Planning and Zoning Commission - Regular Meeting AGENDA

Tuesday, September 15, 2020 at 4:30 PM
Ketchum City Hall
480 East Avenue North, Ketchum, ID 83340

STAFF REPORT
KETCHUM PLANNING AND ZONING COMMISSION
MEETING OF SEPTEMBER 15, 2020

- PROJECT: 4th & Walnut Ave Commercial Development Design Review
- FILE NUMBER: P20-046
- APPLICATION TYPE: Design Review
- APPLICANT: Graham Whipple, Resin Architecture
- PROPERTY OWNER: Walnut & Fourth LLC
- LOCATION: 371 & 391 N Walnut Avenue (Ketchum Townsite: Block 44: Lots 7 & 8)
- ZONING DISTRICT: Retail Core Subdistrict of the Community Core (CC-1)
- NOTICE: The public hearing for this application was continued from the July 13th and August 11th Planning & Zoning Commission Meetings. The project was re-noticed for the public hearing scheduled on the agenda for the September 15th Planning & Zoning Commission Meeting. The public hearing notice for this project was mailed to all owners of property within 300 feet of the project site and published in the Idaho Mountain Express on August 26th, 2020.
- REVIEWER: Abby Rivin, Associate Planner

C0.2

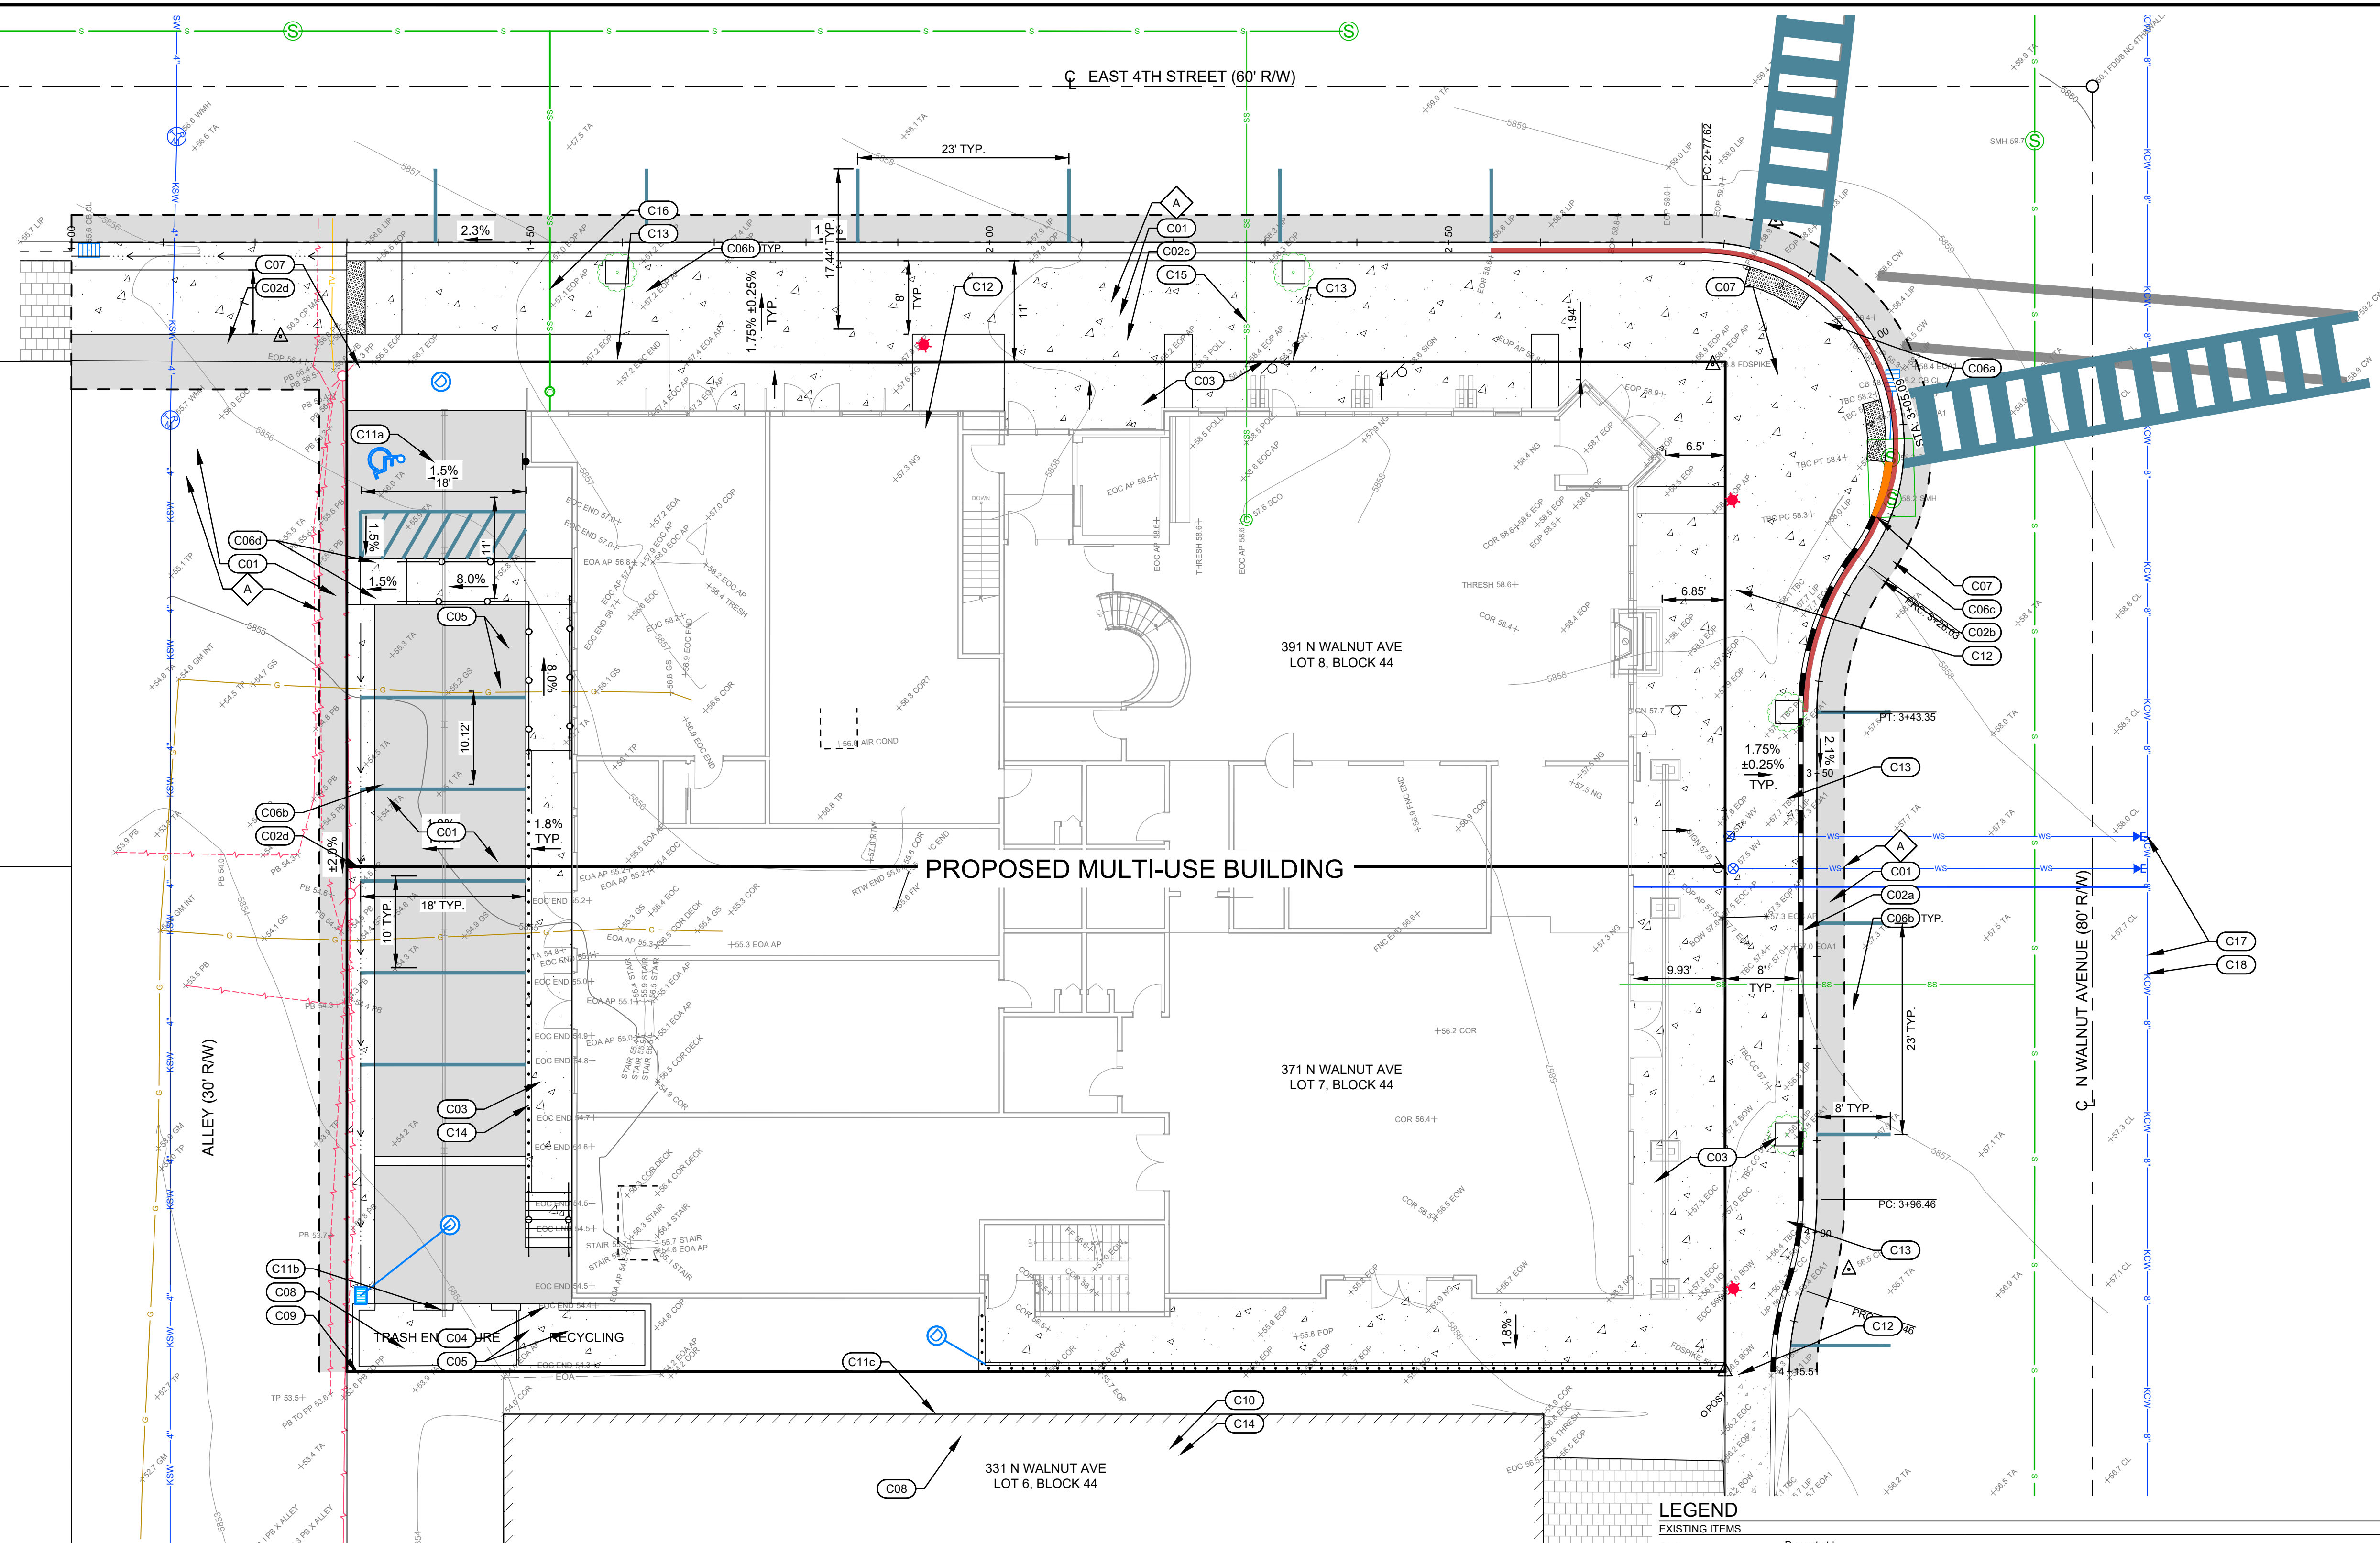
Commission Findings	<p><i>Sheet CO.2 specifies that proposed street trees shall be 3-inches minimum caliper with Autumn Blaze Maple or an approved equal tree.</i></p> <p><i>Street trees may be considered if a snowmelt system is installed for the sidewalks. Streetscape improvements must be indicated on civil plans with the building permit application for final review and approval by the City Engineer and Streets Department. All encroachments within the ROW require an Encroachment Permit issued by the City.</i></p>
<input checked="" type="checkbox"/>	<input type="checkbox"/>	<input type="checkbox"/>	17.96.070(A)(3)	Due to site constraints, the requirements if this subsection 17.96.070(A) may be modified by the Public Works Department.
			Commission Findings	<p><i>Preliminary plans submitted with Design Review are reviewed by the City Engineer and Streets Department in concept only. Modification to the requirements of KMC §17. 96.070(A) may be recommended by the City Engineer and Streets Department following review of the civil drawings submitted with the building permit application. The final civil drawings including the streetscape, sidewalk, utilities, and drainage plans shall be reviewed and approved by the City Engineer, Streets Department prior to issuance of a building permit for the project. Final details and approval will occur during building permit review.</i></p>

DEMOLITION LANDSCAPING PLAN

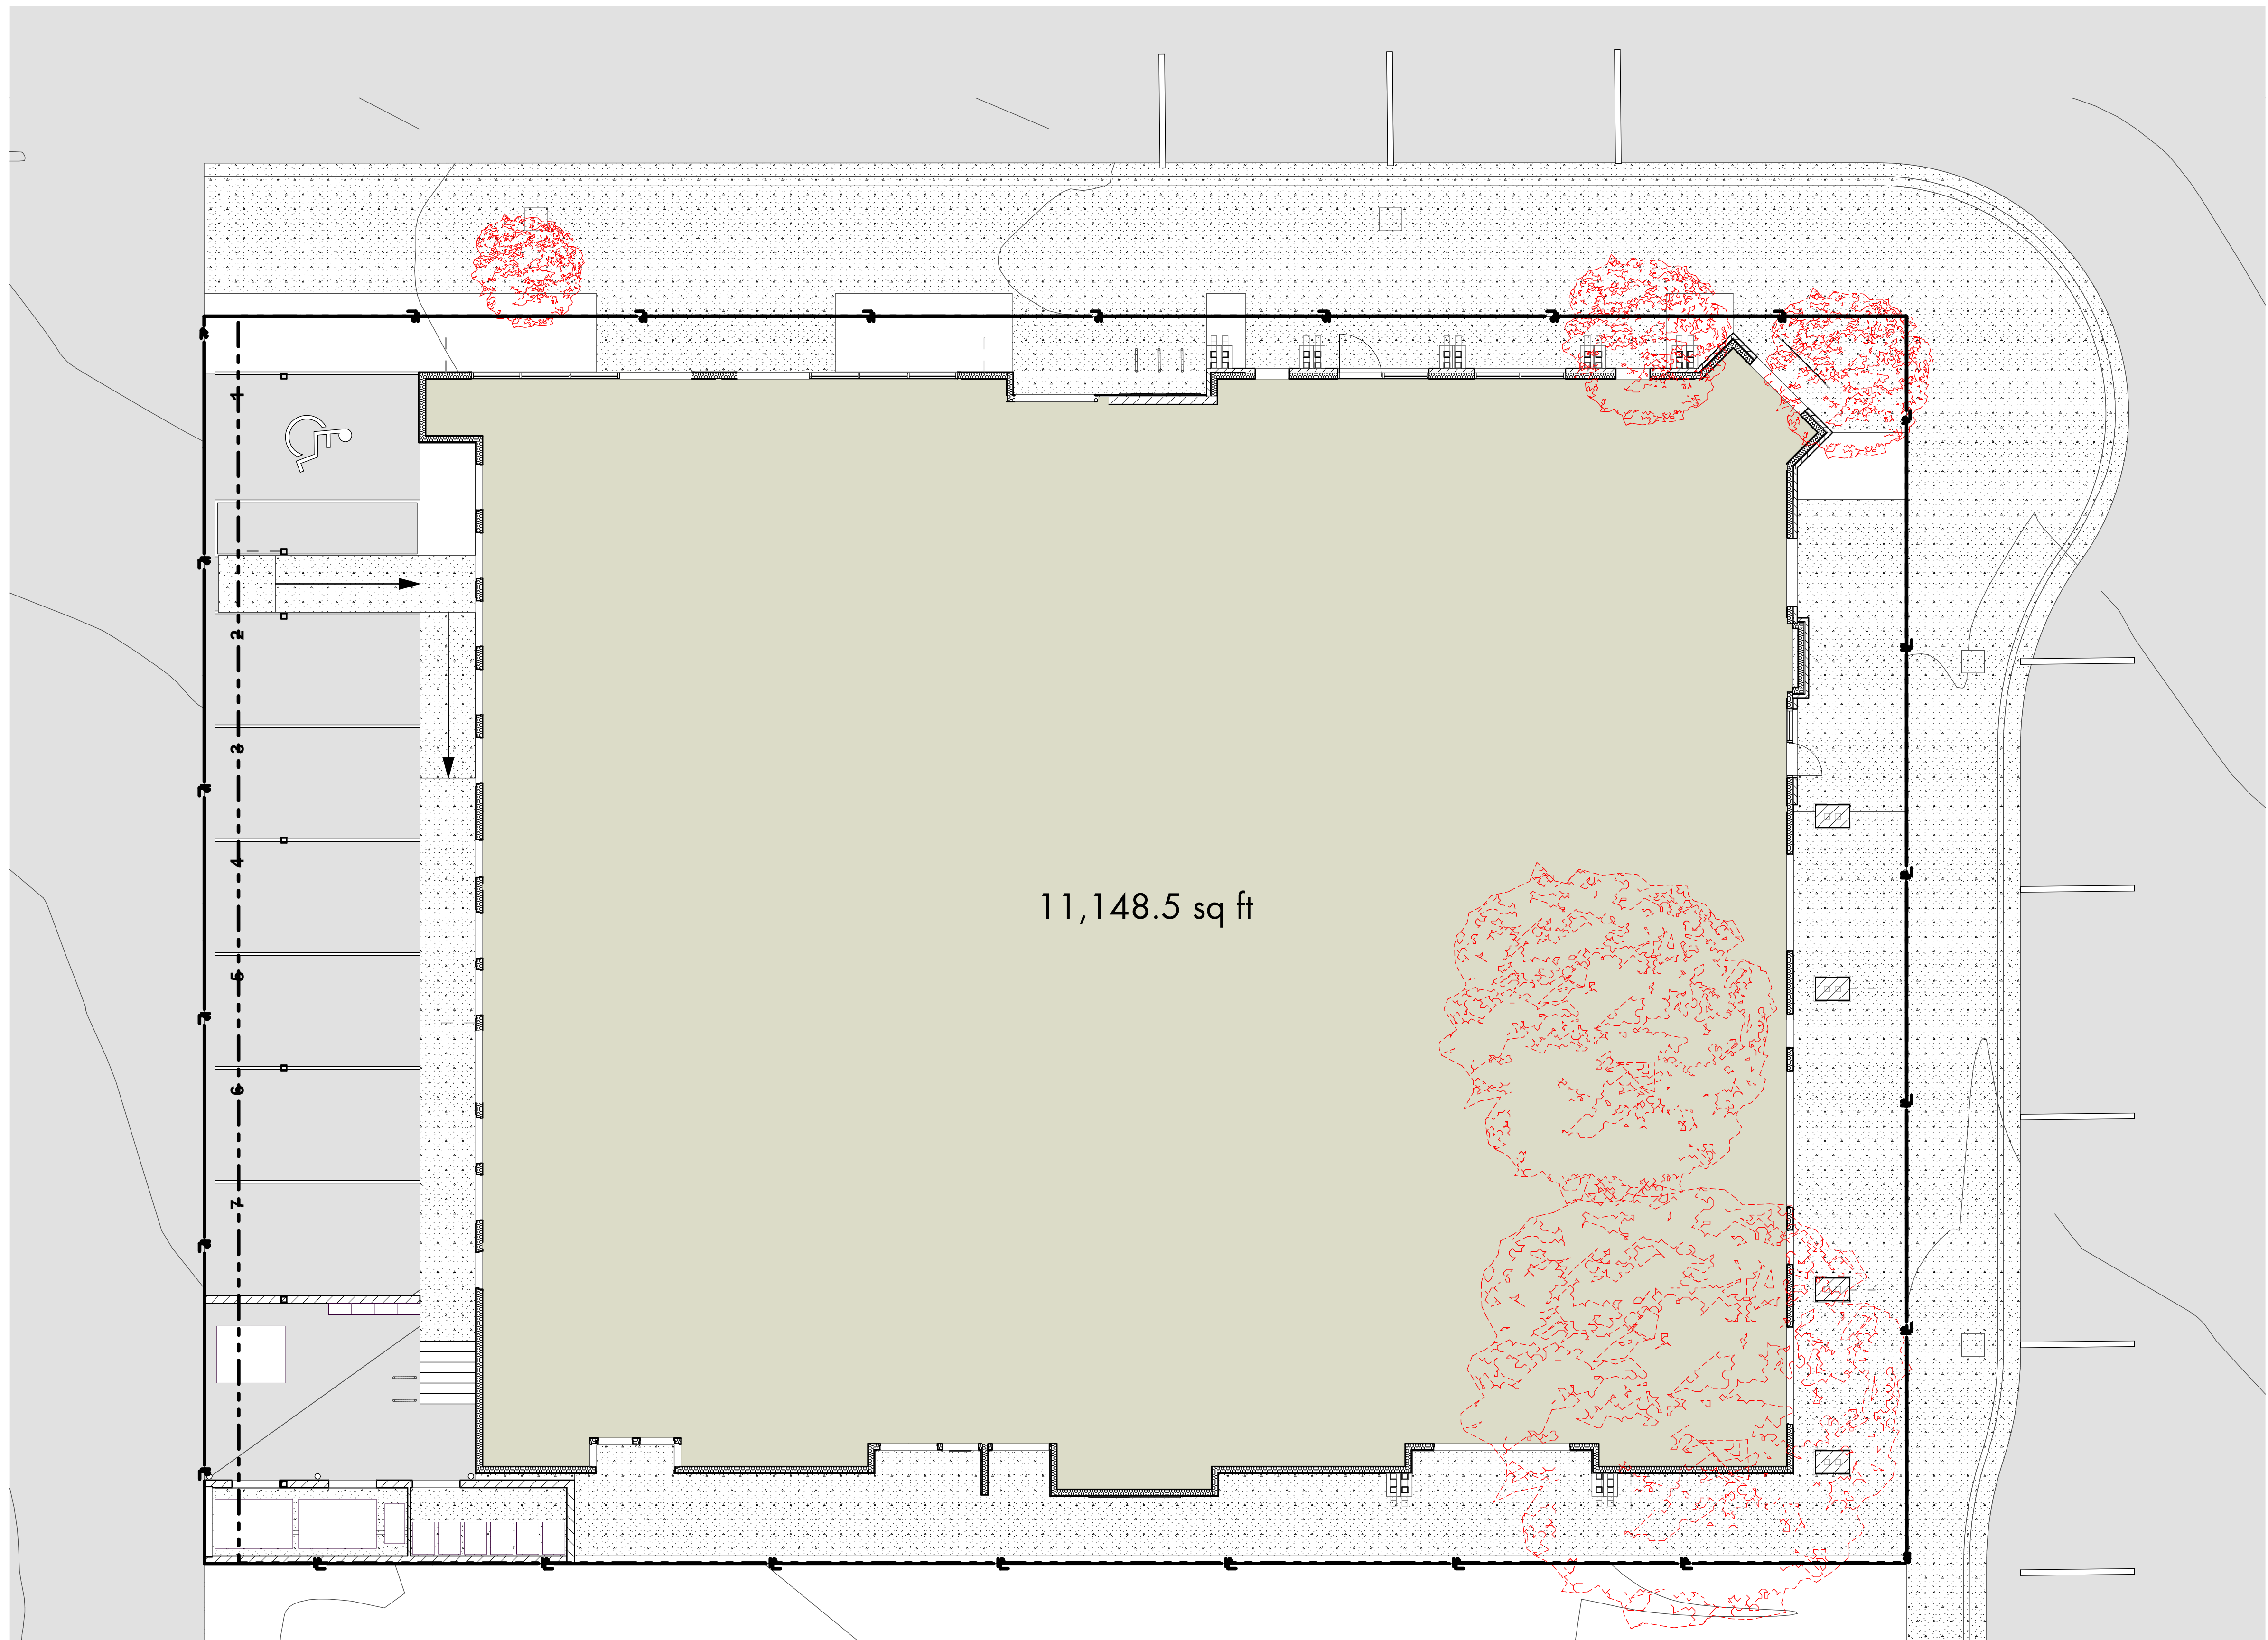
Commission Findings	<p><i>The Demolition Landscaping Plan on Sheet L-1 indicates that 5 mature trees will be removed from the project site to accommodate the new development.</i></p> <p><i>The applicant has proposed four street trees within the ROW along Walnut Avenue and 4th Street. Street trees may be considered if a snowmelt system is installed for the sidewalks. Streetscape improvements must be indicated on civil plans submitted with the building permit application for final review and approval by the City Engineer and Streets Department. If approved by the City Engineer and Streets Department, all encroachments within the ROW require an Encroachment Permit.</i></p> <p><i>The applicant shall coordinate with the City Arborist regarding the placement of off-site replacement trees. The siting of the 5 replacement trees shall be finalized on the project plans submitted with the building permit application for review and approval by the City Arborist, the City Engineer, and the Streets Department. The installation of the 5 replacement trees shall be verified upon final inspection prior to issuance of a Certificate of Occupancy for the project.</i></p>
